**SUNDRY NOTICES AND REPORTS ON WELLS**  
*Do not use this form for proposals to drill or to re-enter an abandoned well. Use form 3160-3 (APD) for such proposals.*

- A. Change of Well Name from: COTTONWOOD 29-32 FEDERAL COM 2H to: COTTONWOOD 29-32 FED COM 2BS 2H
- B. Change Field/Pool Name from: Wildcat; Bone Springs to: Welch Bone Spring
- C. Change Cement Program for Intermediate. See Attached
- D. Plat Attached: Move Location from: 150' FNL and 1070' FWL to: 200' FNL and 1205' FWL

Well Name: Cottonwood 29-32 Federal Com

REF: COTTONWOOD 29-32 FED COM 2BS 2H / WELL PAD TOPO

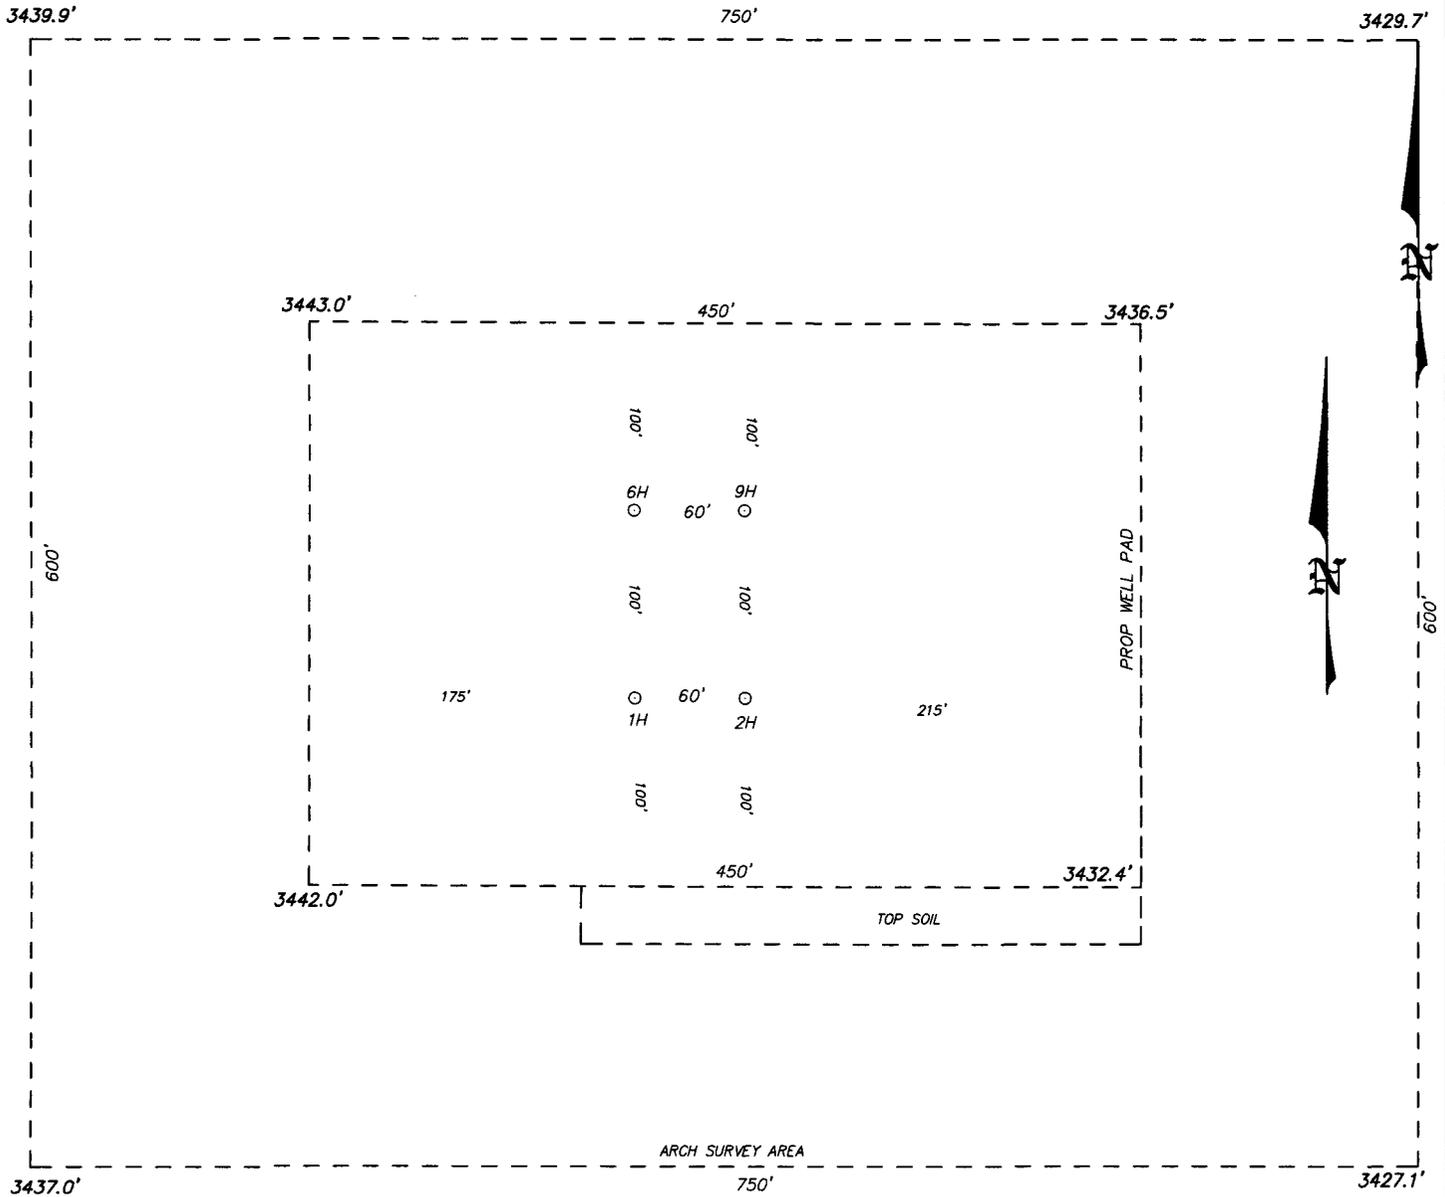
c) Move SHL

From: 150' FNL and 1070' FWL

To: 200' FNL and 1205' FWL

THE COTTONWOOD 29-32 FED COM 2BS 2H LOCATED 200'  
 FROM THE NORTH LINE AND 1205' FROM THE WEST LINE OF  
 SECTION 29, TOWNSHIP 26 SOUTH, RANGE 26 EAST,  
 N.M.P.M., EDDY COUNTY, NEW MEXICO.
